Generic Evaluation of Feedwater Transients and Small Break Loss-of-Coolant Accidents in Combustion Engineering Designed Operating Plants

Office of
Nuclear Reactor Regulation

Manuscript Completed: January 1980
Date Published: January 1980

**Bulletins and Orders Task Force
Office of Nuclear Reactor Regulation
U.S. Nuclear Regulatory Commission
Washington, D.C. 20555**

Arkansas 2
Figure 1

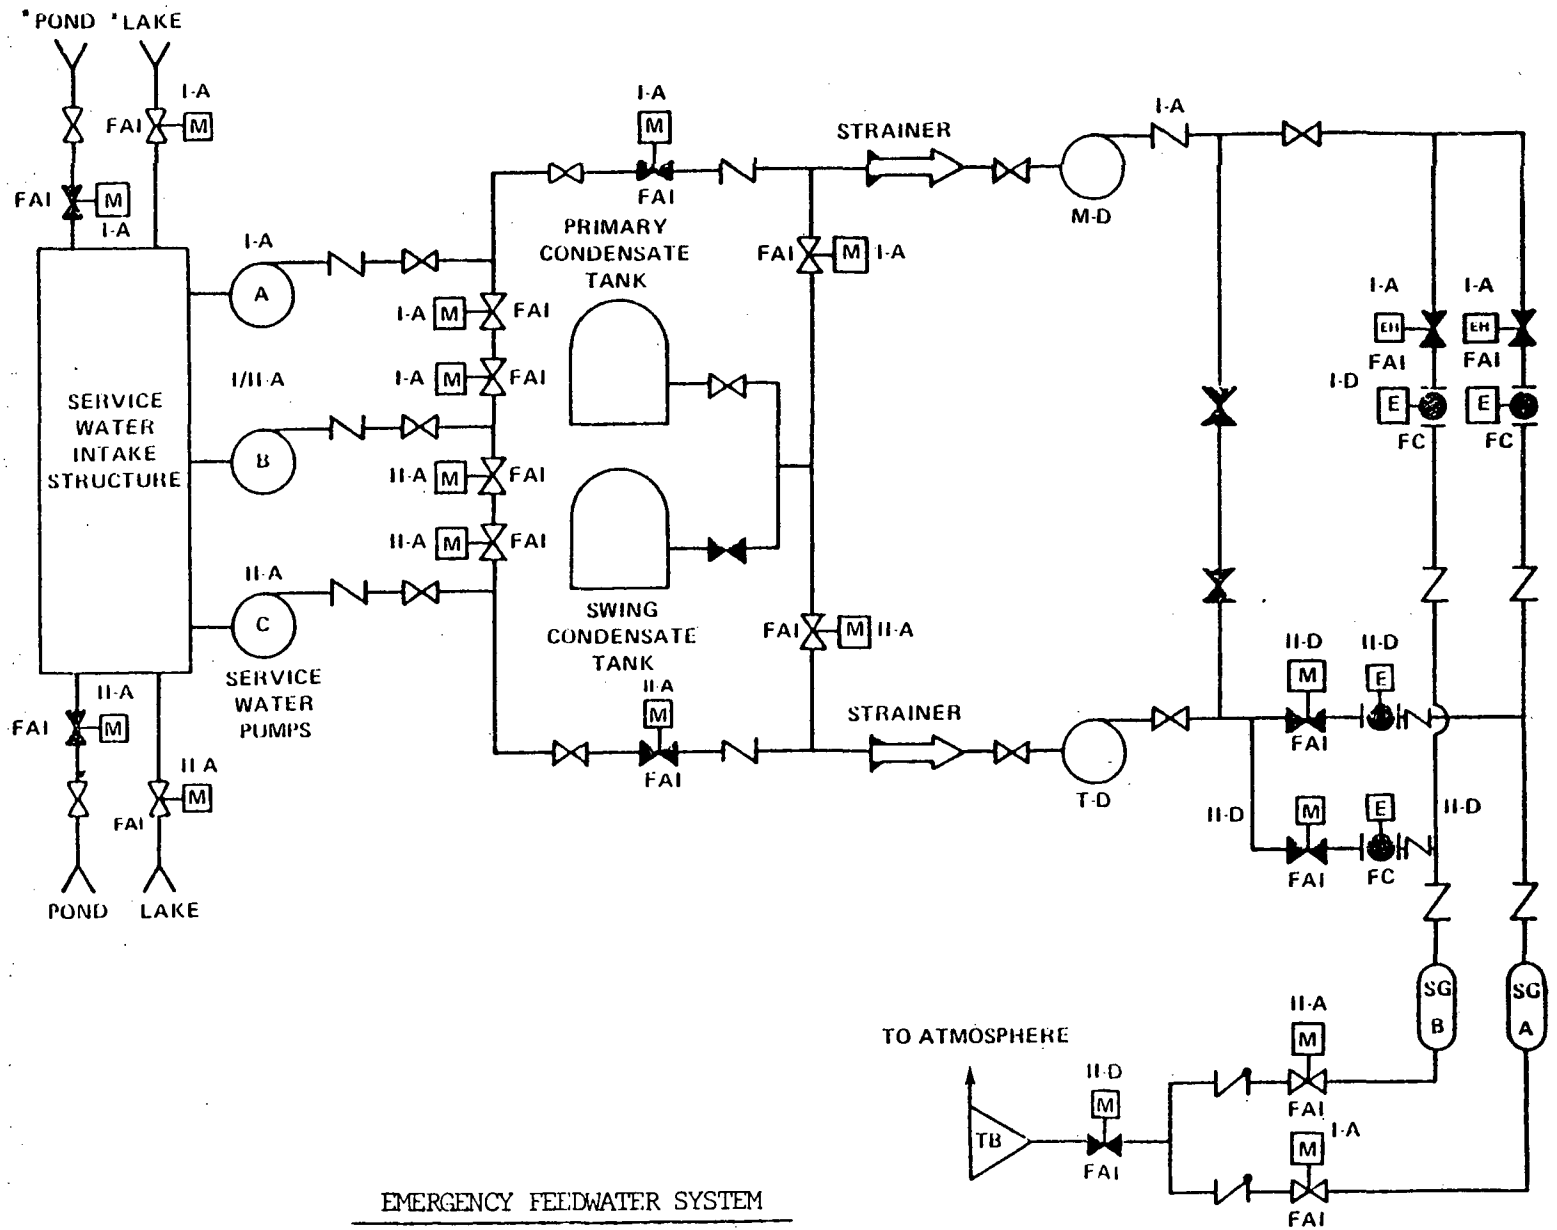
The licensee should evaluate the postulated pipe breaks stated above and (1) determine any AFW system design changes or procedures necessary to detect and isolate the break and direct the required feedwater flow to the steam generator(s) before they boil dry or (2)

describe how the plant can be brought to a safe shutdown condition by use of other systems which would be available following such postulated events.

3. Recommendation - Concern was expressed to the licensee about the capability of the design to isolate a break occurring downstream of the steam admission valve to the turbine-driven pump during AFWS operation concurrent with a single active failure of the DC emergency Division II. Assuming that without DC, the corresponding diesel generator will not be able to start, the break could not be isolated because of the loss of DC and AC power in Division II. The licensee advised that analysis has been performed showing that there is sufficient residual magnetism to flash the diesel generator field and consequently the Division II diesel-generator can be brought up to speed and voltage without the need of DC from the emergency batteries. Thus, the break could be isolated if the failure of the DC emergency Division II does not result also in the loss of AC in the same division. The licensee should submit for staff review the analysis with regard to starting the diesel generator without DC emergency power available.

Auxiliary Feedwater System
Calvert Cliffs, Unit 1 & 2
Figure 1

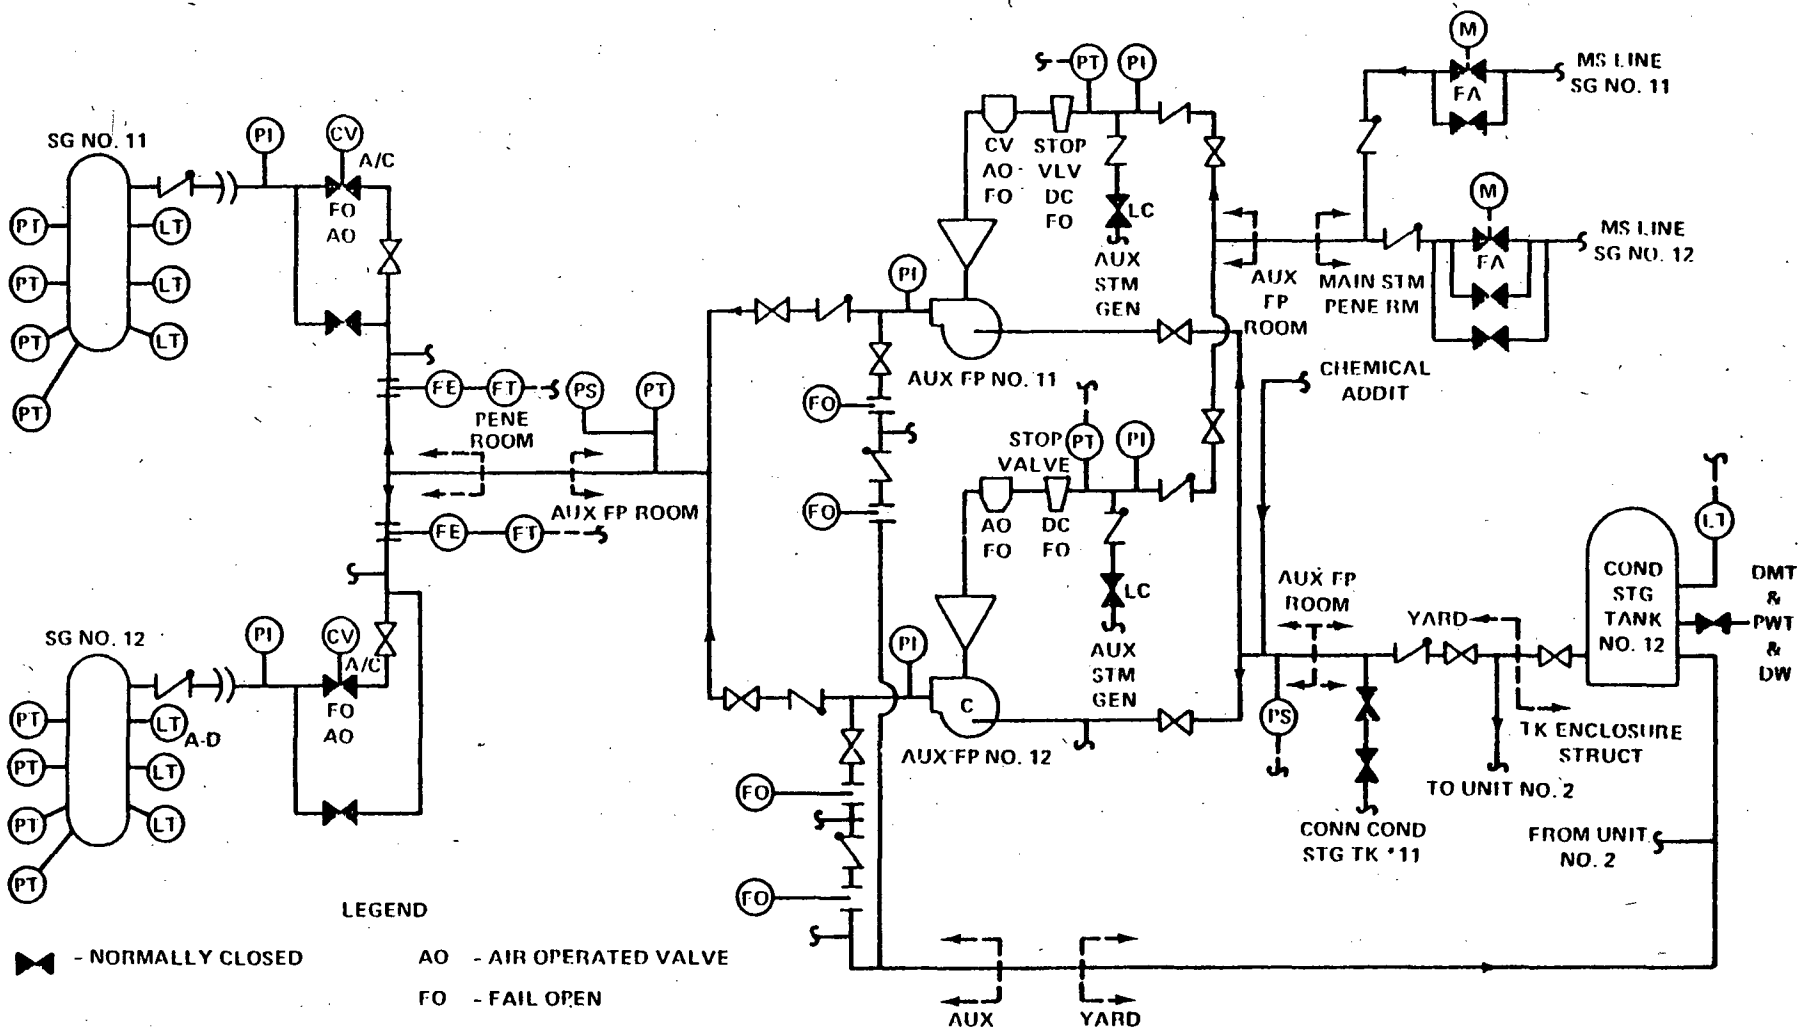
2. Recommendation - GL-2 - Licensees with plants in which all (primary and alternate) water supplies to the AFW systems pass through valves in a single flow path should install redundant parallel flow paths (piping and valves).

Licensees with plants in which the primary AFW system water supply passes through valves in a single flow path, but the alternate AFW system water supplies connect to the AFW system pump suction piping downstream of the above valve(s) should install redundant valves parallel to the above valve(s) or provide automatic opening of the valve(s) from the alternate water supply upon low pump suction pressure.

The licensee should propose Technical Specifications to incorporate appropriate periodic inspections to verify the valve positions.

3. Recommendation - GL-3 - At least one AFW system pump and its associated flow path and essential instrumentation should automatically initiate AFW system flow and be capable of being operated independently of any alternating current power source for at least two hours. Conversion of direct current power to alternating current is acceptable.

5. Recommendations - The licensee should evaluate the following concerns:
 - a) The AFW pump discharge lines and turbine driven AFW steam supply lines combine into different single lines through which all AFW water or steam must flow. (See Figure 1). A pipe break in either of these single flow paths would cause loss of the entire AFW function.
 - b) The Calvert Cliffs AFW systems do not meet the high energy line break criteria in SRP 10.4.9 and Branch Technical Position 10-1; namely, that the AFW system should maintain the capability to supply the required flow to the steam generator(s) assuming a pipe break anywhere in the AFW pump discharge lines concurrent with a single active failure.

Auxiliary Feedwater System
Ft. Calhoun
Figure 1

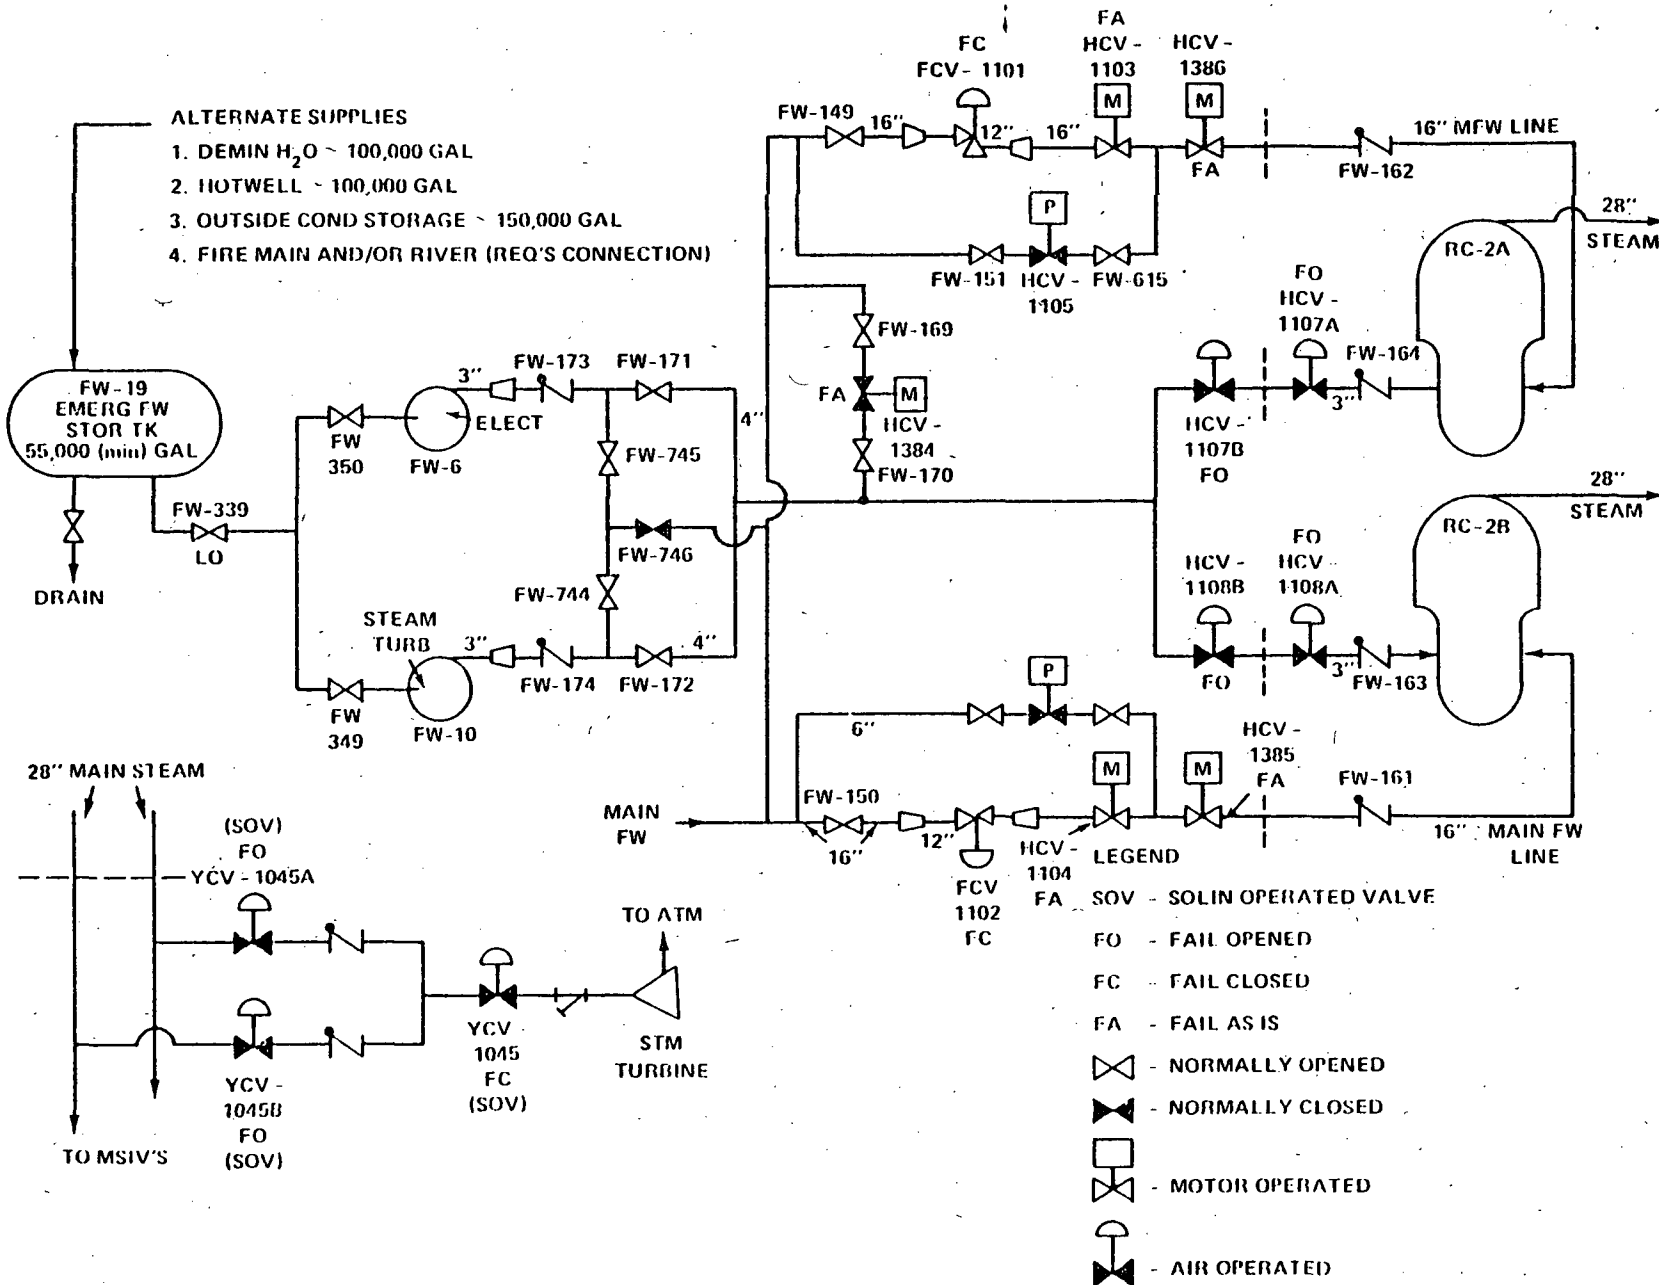
6. Since valves FW 744 and 745 in one of the AFW pump discharge headers are normally open (see Figure 1), a postulated break in this header would cause loss of the capability to provide AFW flow to both steam generators. The licensee should re-evaluate the position of these valves considering such a postulated pipe break to revise the valve alignment to reduce the impact of such an event on the AFW capability (e.g., close valves FW 744 and FW 745).

2. Recommendation GL-2 - Licensees with plants in which all (primary and alternate) water supplies to the AFW systems pass through valves in a single flow path should install redundant parallel flow paths (piping and valves).

Licensees with plants in which the primary AFW system water supply passes through valves in a single flow path, but the alternate AFW system water supplies connect to the AFW system pump suction piping downstream of the above valve(s) should install redundant valves parallel to the above valve(s) or provide automatic opening of the valve(s) from the alternate water supply upon low pump suction pressure. The licensee should propose Technical Specifications to incorporate appropriate periodic inspections to verify the valve positions.

3. Recommendation - GL-5 - The licensee should upgrade the AFW system automatic initiation signals and circuits to meet safety-grade requirements.

4. Recommendation - The licensee should evaluate the following concerns:

**Auxiliary Feedwater System
Maine Yankee
Figure 1**

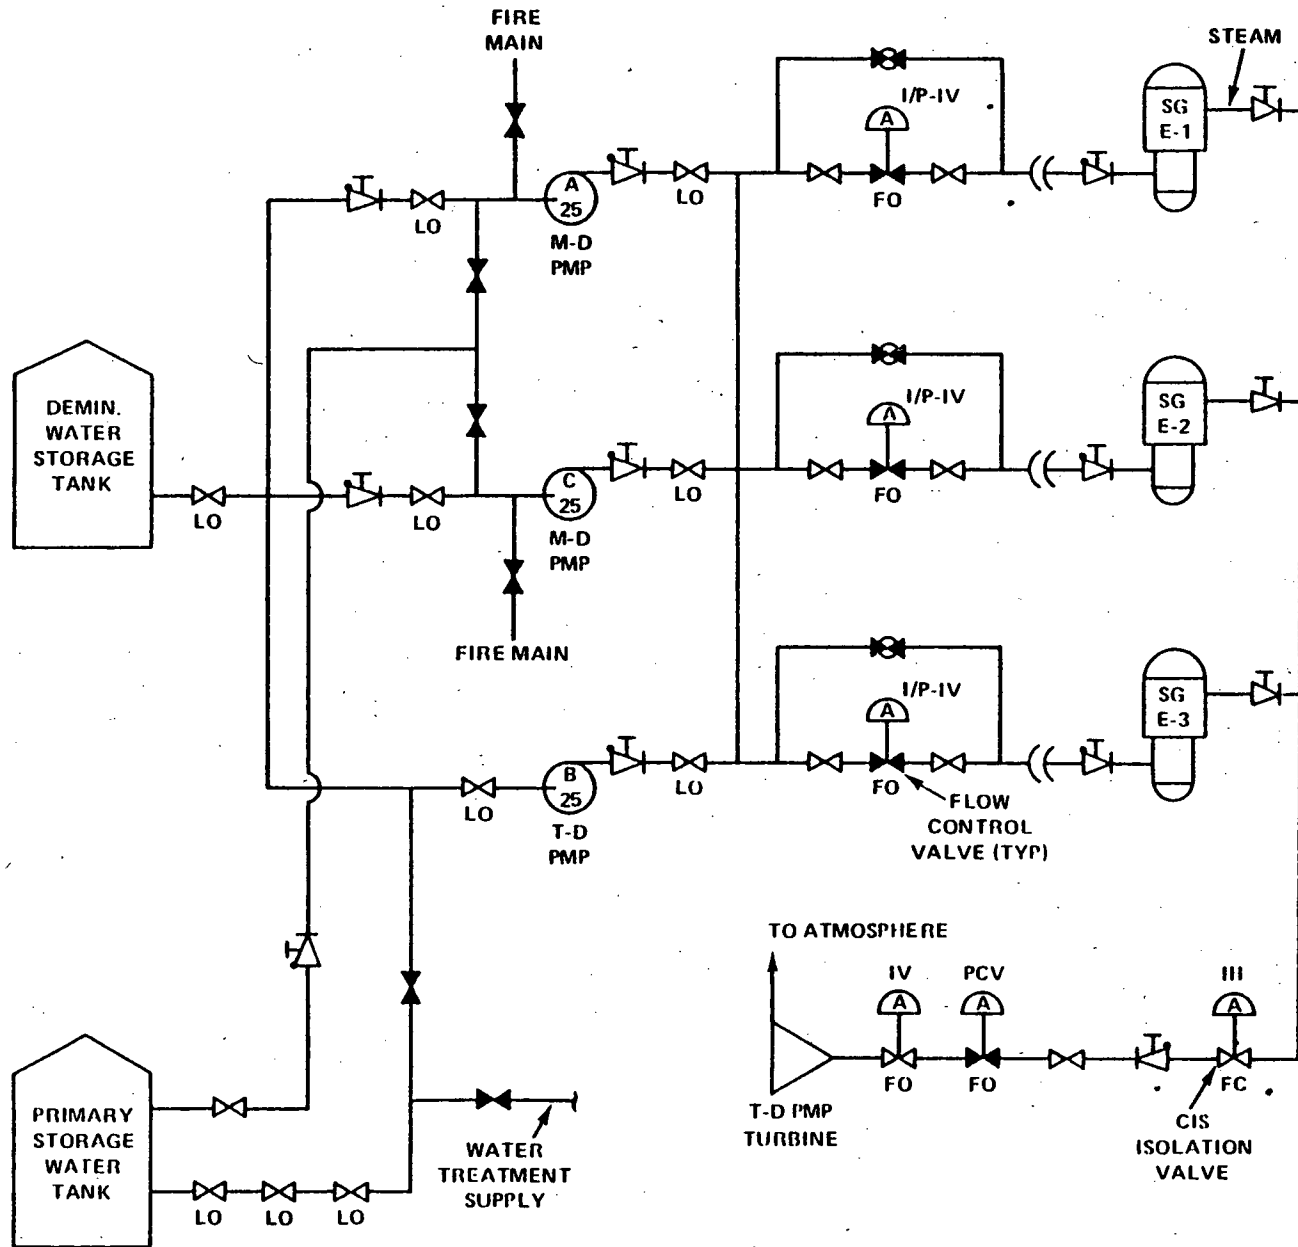
Licensees with plants in which the primary AFW system water supply passes through valves in a single flow path, but the alternate AFW system water supplies connect to the AFW system pump suction piping downstream of the above valve(s) should install redundant valves parallel to the above valve(s) or provide automatic opening of the valve(s) from the alternate water supply upon low pump suction pressure. The licensee should propose Technical Specifications to incorporate appropriate periodic inspections to verify the valve positions.

3. Recommendation - Modify the AFWS design to eliminate the potential for adverse response of the three AFW flow control valves and one of the steam admission valves to the turbine pump due to degradation of power of the Division IV vital bus, e.g., provide service to these valves from different Division.

4. Recommendation - The licensee should evaluate the following concerns:
 - a. A pipe break in the auxiliary feedwater system common discharge header could result in the loss of auxiliary feedwater system function even without a postulated single active failure. The licensee indicated that in such an event the auxiliary feedwater can be manually routed through the main feedwater lines to the steam generators.

- b. In the event of a steam or feedwater line break (main or auxiliary) the isolation of the auxiliary feedwater flow paths to the affected steam generator is accomplished manually. The licensee should evaluate the postulated pipe breaks stated above and (1) determine any AFW system design changes or procedures necessary to detect and isolate the break and direct the required feedwater flow to the steam generator(s) before they boil dry or (2) describe how the
